23043-01-001

**St. John's Convent,
New Street, Rathangan**

ROAD SAFETY AUDIT STAGE 1 / 2

2.1 Problem

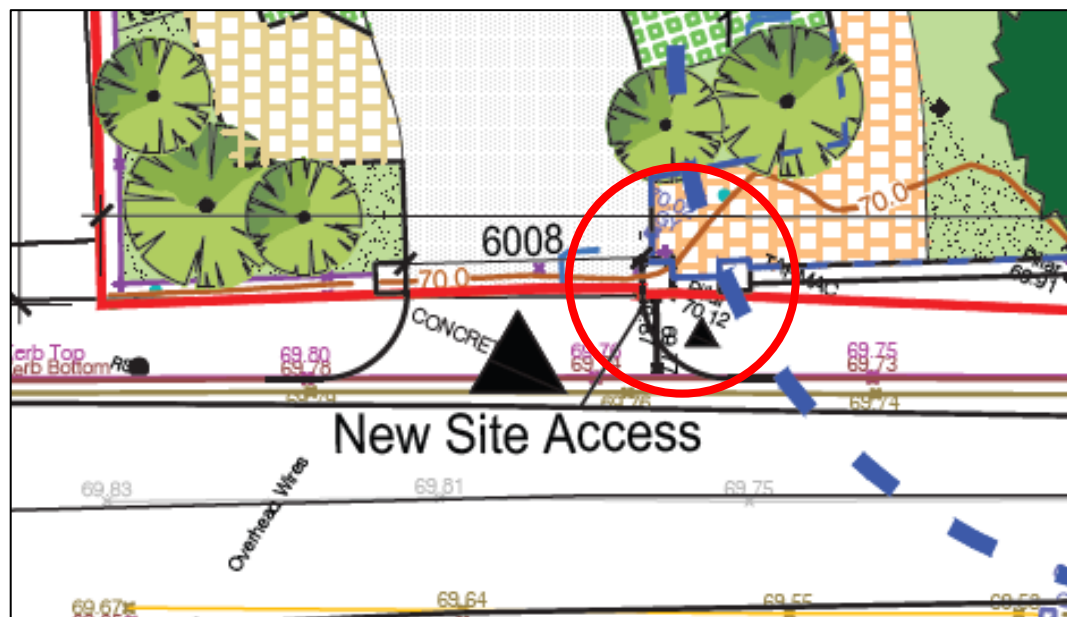
Intervisibility between drivers of vehicles exiting the proposed development and pedestrians travelling along the existing footpath may be restricted by the proposed boundary walls and piers either side of the access. A lack of adequate intervisibility at this location may contribute to a pedestrian collision at the proposed access.

Revise the layout to ensure that adequate intervisibility between drivers of vehicles exiting the proposed development and pedestrians travelling along the existing footpath is provided.

2.3 Problem

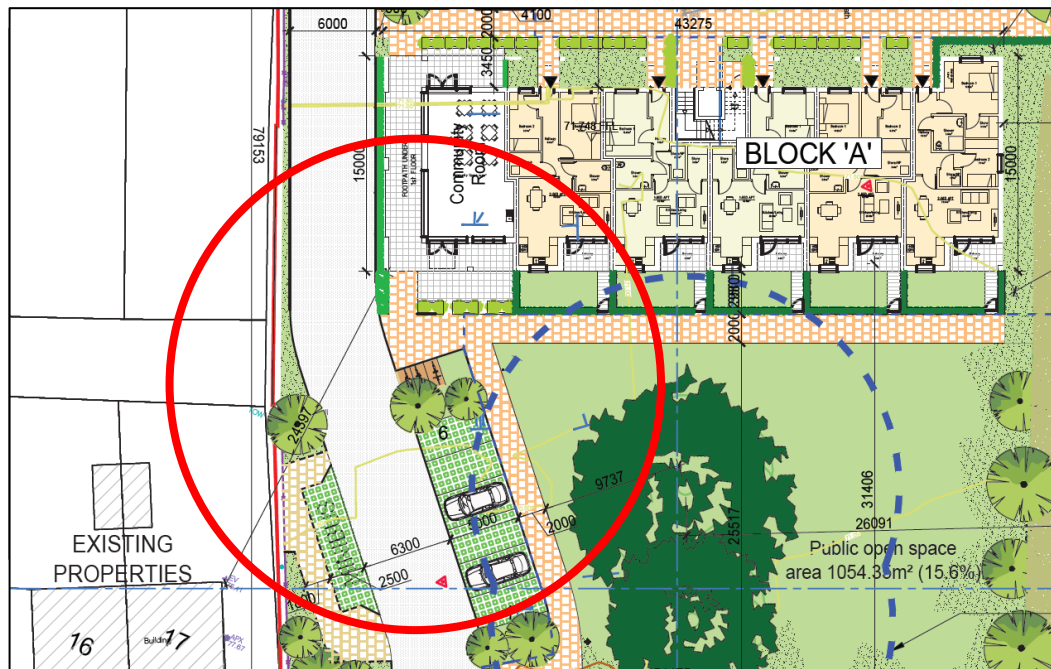
A minibus set-down area is proposed within the development on the west side of the access road with a footpath to the rear of the set-down area. However, the main footpath linking to the housing units within the development is located on the east side of the access road and an appropriate link to this footpath is not shown to be provided from the minibus set-down area. A lack of an appropriate footpath link may result in pedestrians travelling along the access road where they would be at an increased risk of being struck by a passing vehicle.

Provide an adequate footpath link from the minibus set-down to the proposed footpath on the east side of the access road.

2.4 Problem

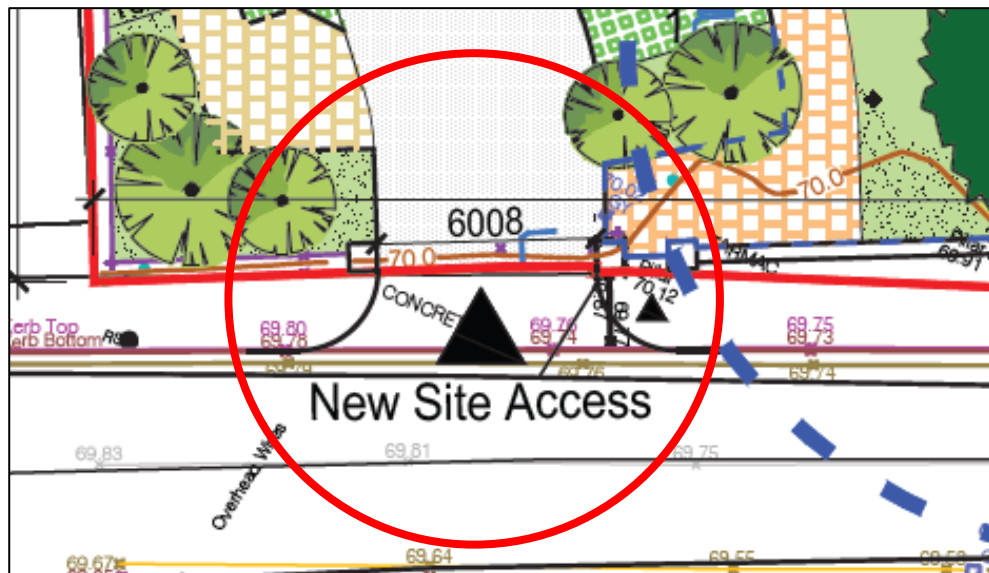
A minibus set-down area and parking spaces are proposed immediately within the development in close proximity to its junction with the R414. Intervisibility between drivers of vehicles entering the proposed development and drivers of vehicles turning to and from these parking spaces may be restricted by the proposed roadside boundaries. A lack of adequate intervisibility may contribute to a collision at this location.

Provide measures to ensure that adequate intervisibility between drivers of vehicles entering the proposed development and drivers of vehicles turning to and from these parking spaces is provided. Such measures could include lowering the roadside boundaries, provision of a raised crossing at the proposed access etc.

2.6 Problem

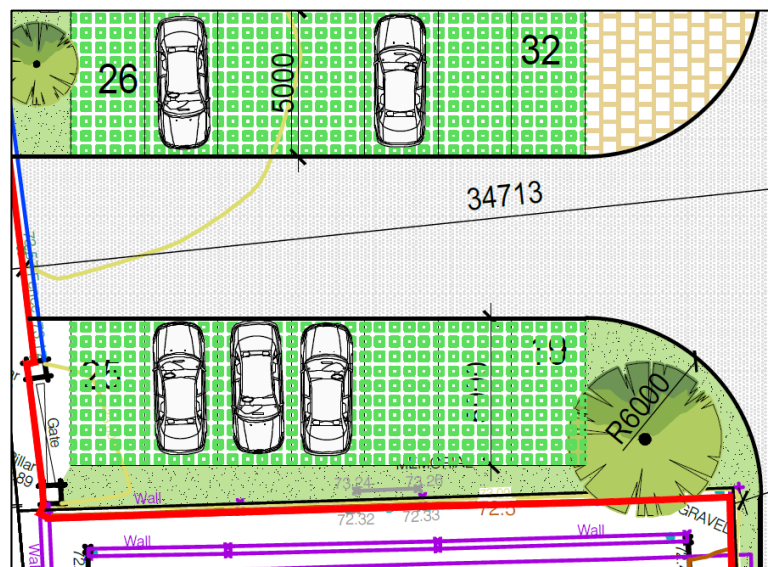
A footpath is not shown to be provided to accommodate pedestrians travelling to and from the parking spaces on the south side of the turning head within the proposed development. A lack of an appropriate footpath link may result in pedestrians travelling along the access road where they would be at an increased risk of being struck by a passing vehicle.

Provide an adequate footpath link from these parking spaces to the proposed footpath on the east side of the access road.
